Global Nuclear Fuel

Subject: GNF-A's Response to the NRC's 3/15/05 RAI for the Model RA-3 Package – TAC No. L23695

Response To NRC RAI For Model No. RA-3

**Figure 10(a). Rectangular Deformation Spacing Effects [10x10 Assembly]
 k_{eff} vs Assembly Spacing - 360 Unit Array**

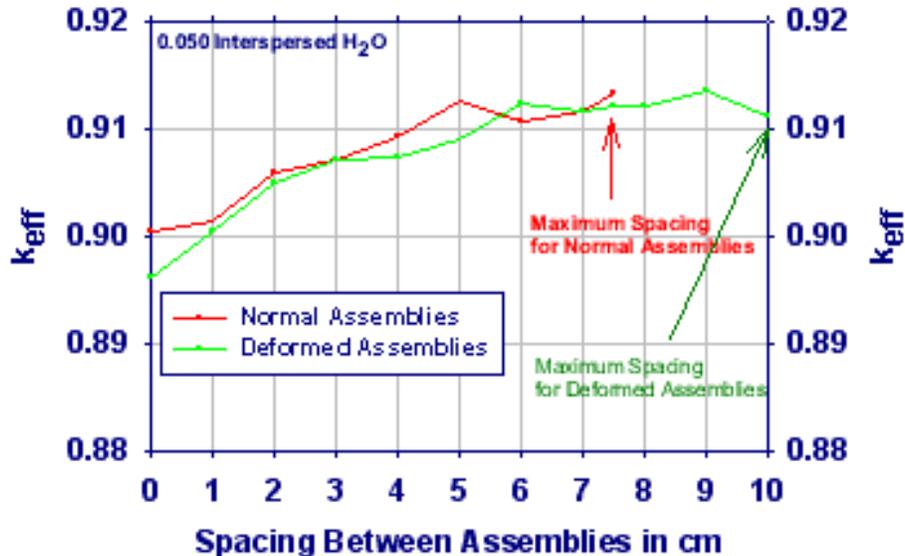
6-1 Justify the assumed fuel assembly positioning within the RA-3 basket cells for the analysis of the damaged package array case.

In the current analysis, the fuel assemblies are nearly centered vertically and horizontally in the individual RA-3 basket cells. No analysis was performed to determine the most reactive positioning of the assemblies within the basket. It is noted that in a previous amendment, some analysis of assembly positioning had been performed; however, it did not include modeling the assemblies placed at the maximum horizontal separation from each other (within the basket). Staff calculations indicate that the positioning used in the current analysis is not the most reactive the damaged array case. Justification for the assumed assembly positioning in the current analysis should include an analysis of various assembly positions, including maximum horizontal separation, to demonstrate the most reactive positioning of the assemblies has been identified. A discussion of any other bases for selecting the assembly should also be included.

The damaged package array has been revised to include an independent assessment of the maximum spacing of the fuel assemblies within the basket region of the RA-3 inner container. This work is premised on prior work for a similar RA-series container (RA-3D) analysis, that demonstrates the maximum reactivity occurs when the fuel assemblies are physically spaced farthest apart - as shown in Figure 10(a) below.

As noted on page 5 footnote of the prior RA-3 application, the RA-3D is nearly identical to the RA-3 container; however, the RA-3D container differs in that the inner container material is fabricated out of stainless steel 321 rather than carbon steel. Dimensionally, the neutronic models used in criticality safety demonstrations are equivalent. The absolute magnitude of the delta-k reactivity effect of the fuel assembly spacing would be expected to be different for the carbon steel inner used in the RA-3 nuclear package, but the overall reactivity trend the same.

The above forms the basis for the maximum horizontal spacing study contained in the revised RA-3 submittal. The analysis for GNF2 fuel has been revised to incorporate this new study and demonstrates that indeed, the most limiting damaged package array occurs for this configuration. In fact, since the prior GNF2 safety demonstration was very near the established USL = 0.933, the limiting damaged package array size was required to be adjusted to $2N = 9 \times 15 \times 1 = 135$ unit close-packed array. [The previous $2N = 10 \times 16 \times 1 = 160$ unit array size slightly exceeded the established USL, by one-tenth of one percent delta-k or 0.001]. The associated CSI for the RA-3 containing GNF2 fuel is revised to reflect this limiting condition damaged package array size.
